# 6-30 Artarmon Road & 15 Richmond Avenue, Willoughby

S75W DESIGN RESPONSES  
Prepared for the Department of Planning, Industry and Environment

1st JUNE 2020

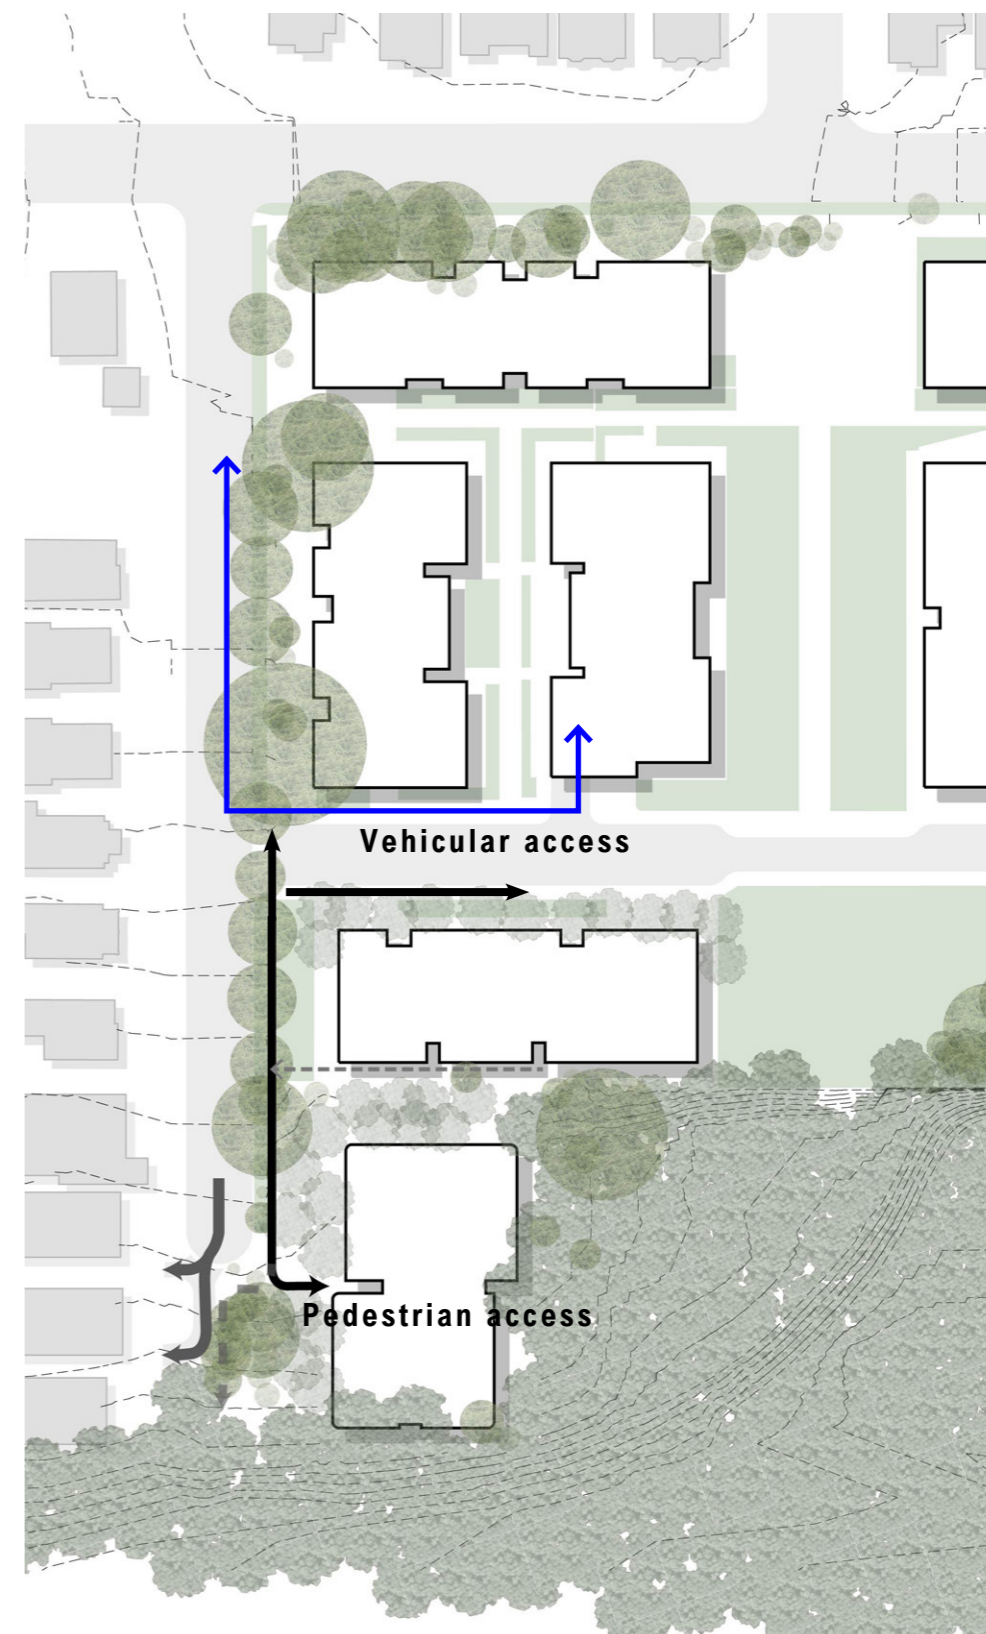
“Access: although the underground car park is accessed from Scott Street, the only pedestrian access appears to be from Richmond Avenue, with no pedestrian links to the rest of the site except via Richmond Avenue. This suggests that visitors, deliveries, and quite possibly residents, will find it more attractive to use Richmond Avenue to access the building causing extra traffic and parking impacts (including the potential for delivery vehicles blocking the driveway accesses at the end of Richmond Ave). This could be addressed by making Building K more clearly part of the main site with ground-level pedestrian links.”

Presently the site has vehicle access via Richmond Avenue for servicing the transmission tower.

The Building K proposal will remove the existing vehicle access point and include a single pedestrian access point from Richmond Avenue which is considered an improved urban outcome and creates an important street presence for Building K that encourages passive surveillance.

Resident and visitor parking, garbage collection and service vehicle access will all be provided underground via Scott Street and linked to the building with direct lift access, limiting the vehicle movement to Richmond Avenue.

1.4 AMENITY  
INDICATIVE SOLAR ACCESS PLANS

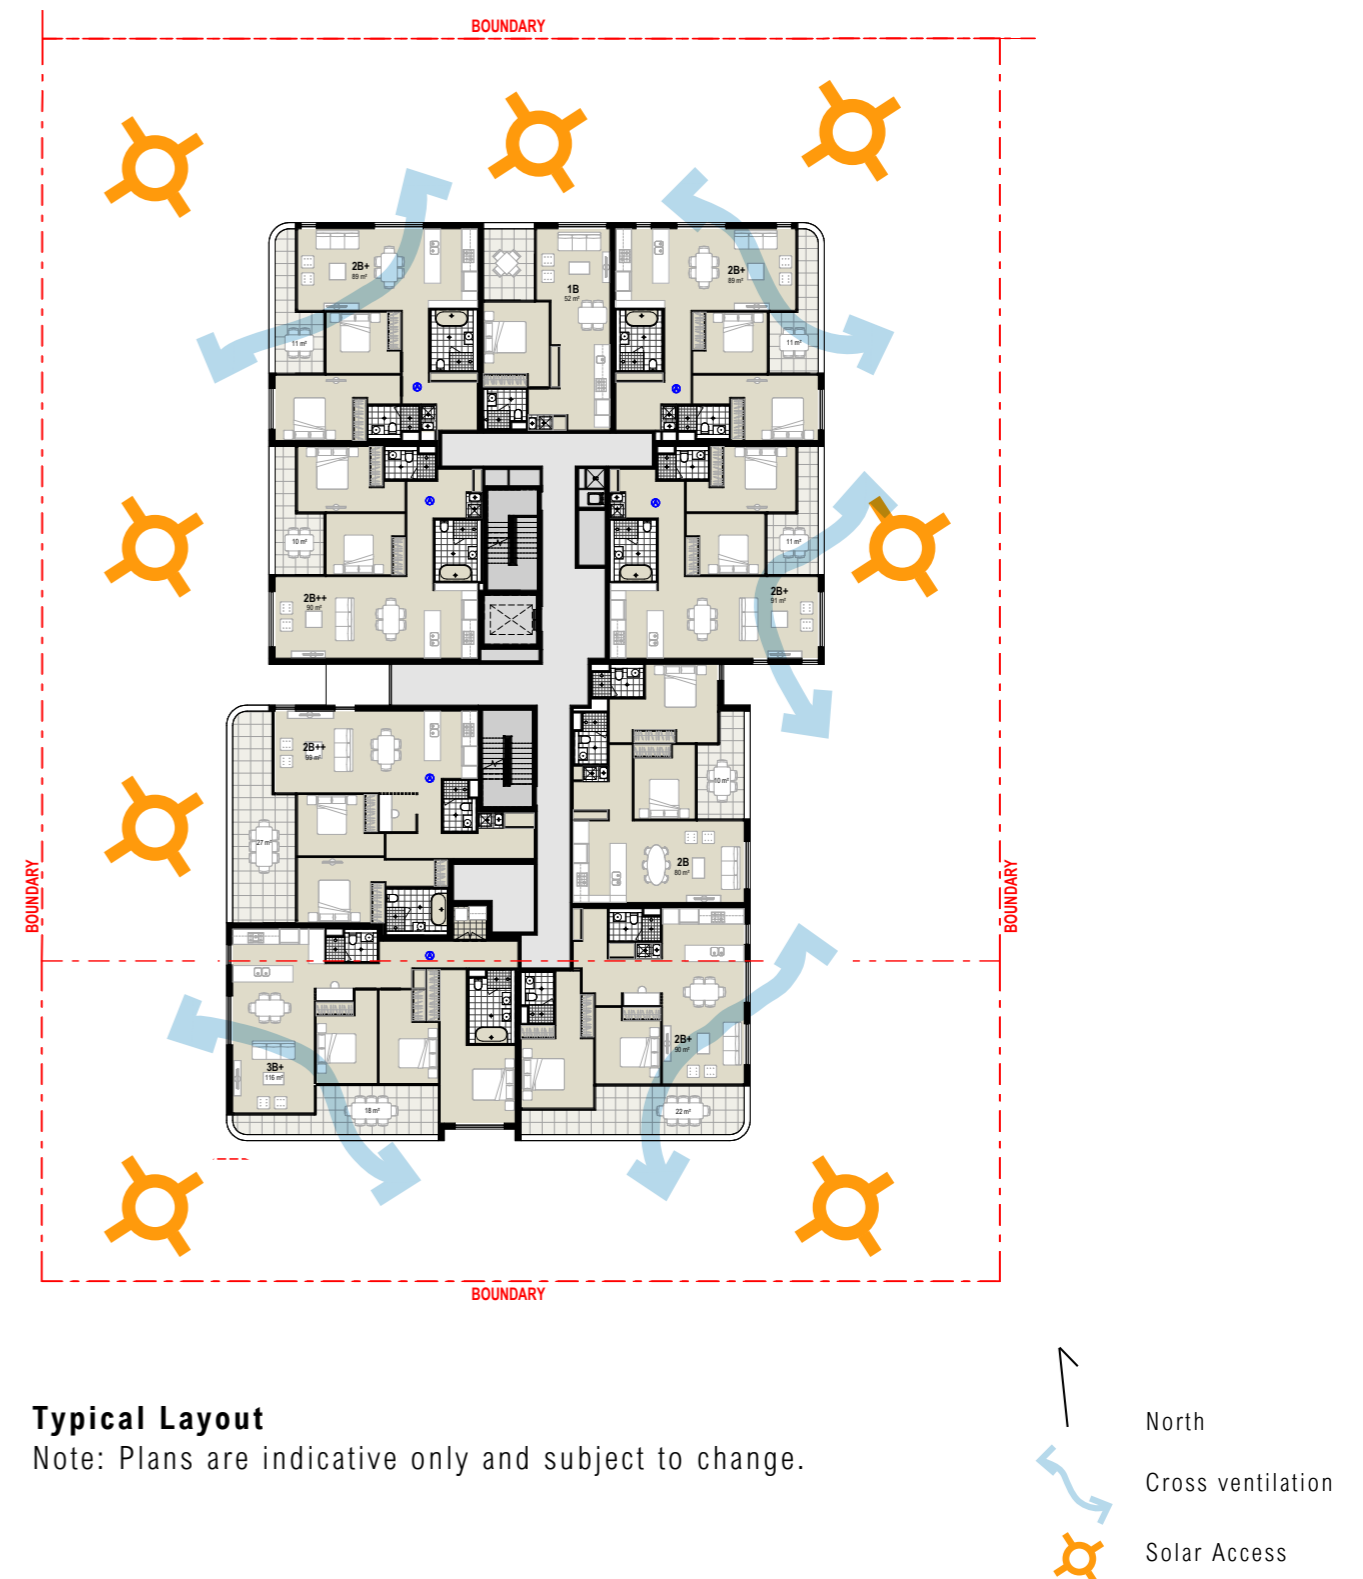
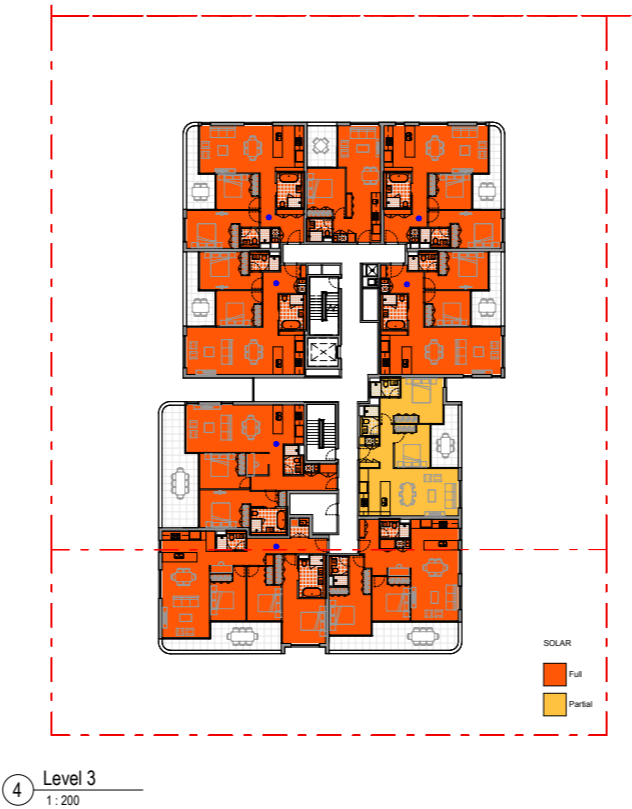
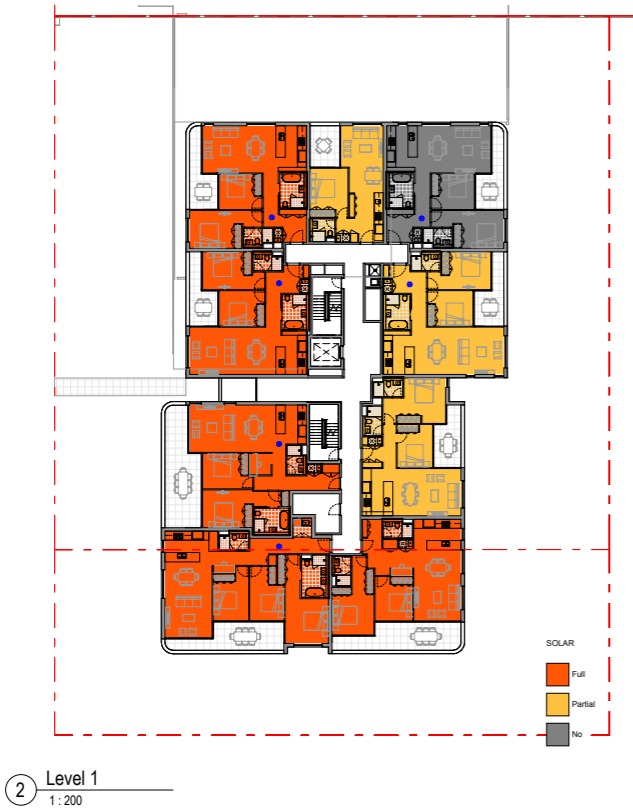
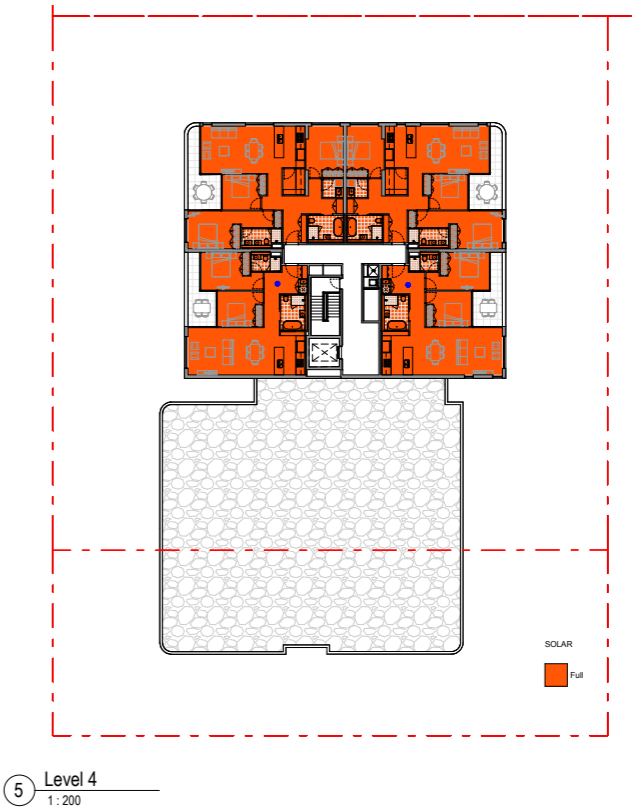
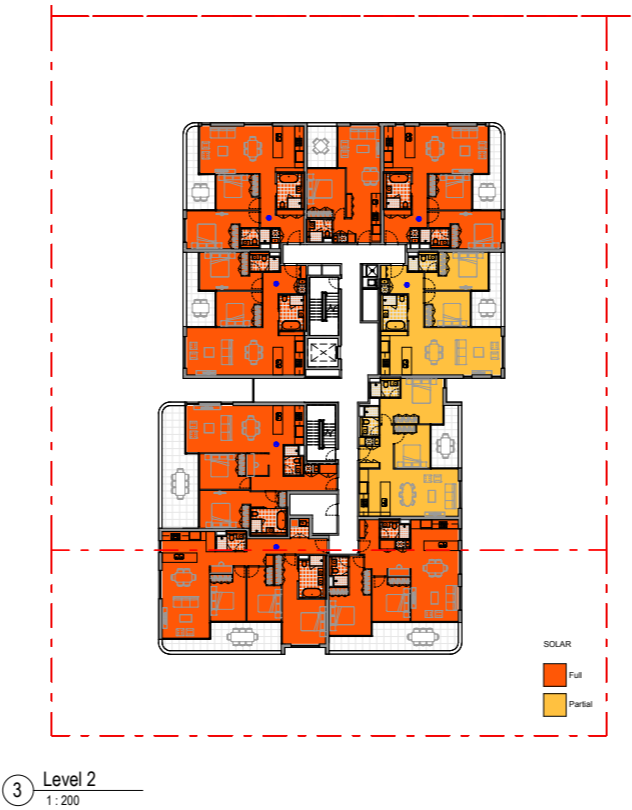
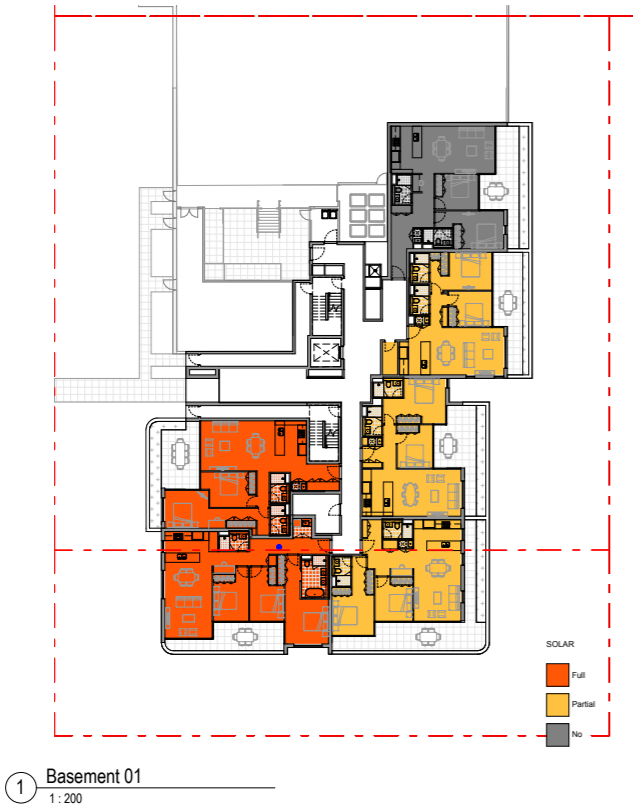
Provide indicative apartment layout plans to demonstrate the future building is capable of delivering a high level of amenity in line with the ADG in terms of solar access and natural ventilation.

The following indicative plans demonstrates that a future building in this envelope can achieve a high level of amenity for the building.

Indicative floor plans could achieve good solar access, with 70% of apartments receiving the required minimum of 2 hrs solar access between 9am and 3pm on the 21 June (mid winter).

Good apartment orientation and outlook will also be considered with the indicative design showing a majority of apartment experiencing dual aspects and only one apartment with a single aspect to Building H which will have appropriate landscaping treatments between.
